Metropolitan Development Commission Regional Center Hearing Examiner (July 27, 2023) Meeting Agenda

STAFF REPORT

REGIONAL CENTER HEARING EXAMINER - HIGH IMPACT CASE

Case Number	2023-REG-055
Address (approx.)	1341 and 1401 Dr. Martin Luther King, Jr. Street and 453 West 14 th Street
Location	Center Township, Council District # 11
Petitioner	KTKF Holdings, LLC, by Jamilah Mintze
Zoning	SU-1 (RC) and D-8 (RC) (D-9 (RC) pending)
Request	Regional Center Approval for demolition of an existing structure and for construction of a multi-family residential development consisting of 36 dwellings.

LANDSCAPE | OVERALL PLAN

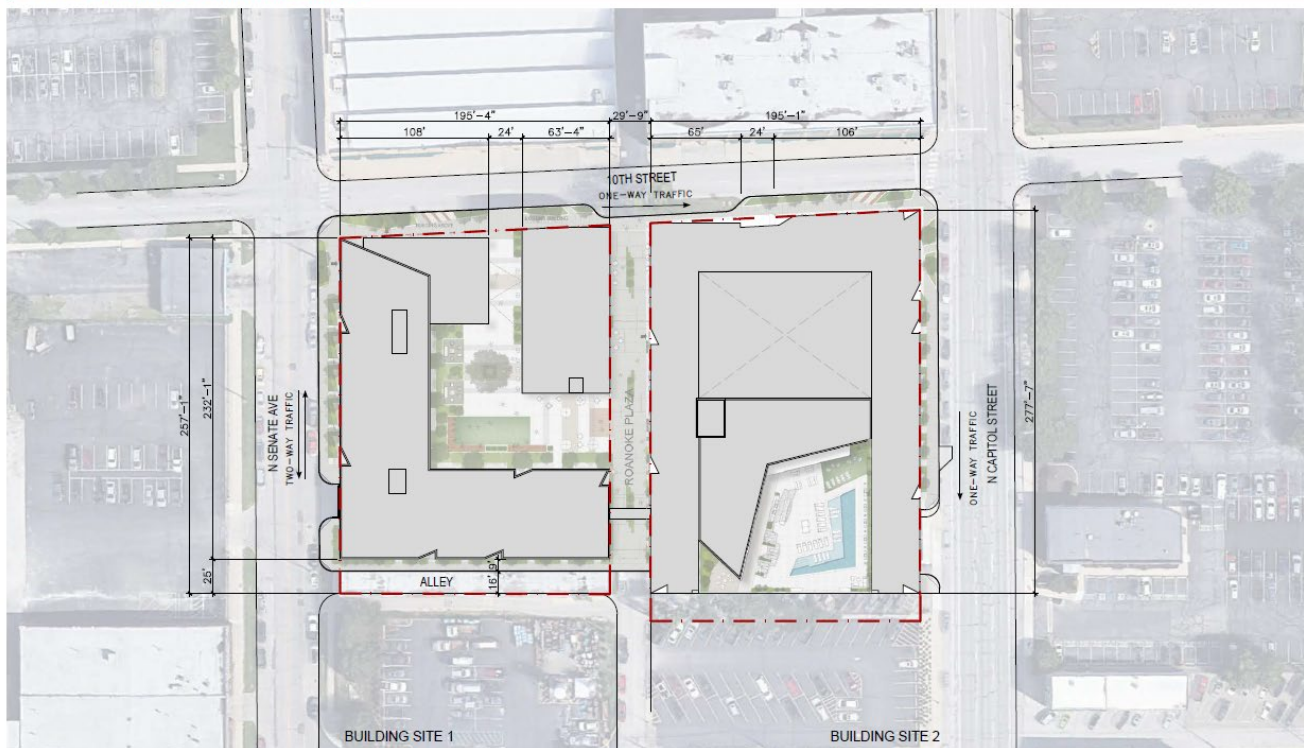
3. A Landscape plan was submitted, but it does not detail the plantings. A landscape plan shall be submitted for staff review and approval prior to issuance of an Improvement Location Permit. Guidelines US 1.3.2, CA 4.6.1, CA 4.6.4, and CA 4.6.6 would apply.

ELEVATIONS | BUILDING SITE 1 - EAST

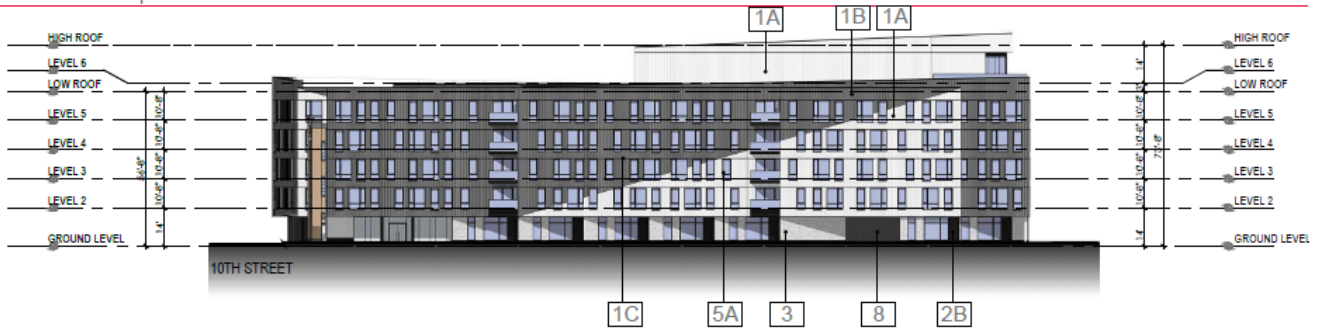
2. The south elevation of the proposed building along Capitol Avenue indicates that the garage parking levels would have vertical building material to cover exposed sections, for ventilation purposes. However, detail of this vertical building material was not submitted with the filing. Staff would suggest that details of this building material be submitted and subject to staff review and approval, prior to the issuance of an Improvement Location Permit. Guidelines SC 3.3.2 and SC 3.3.3 apply.
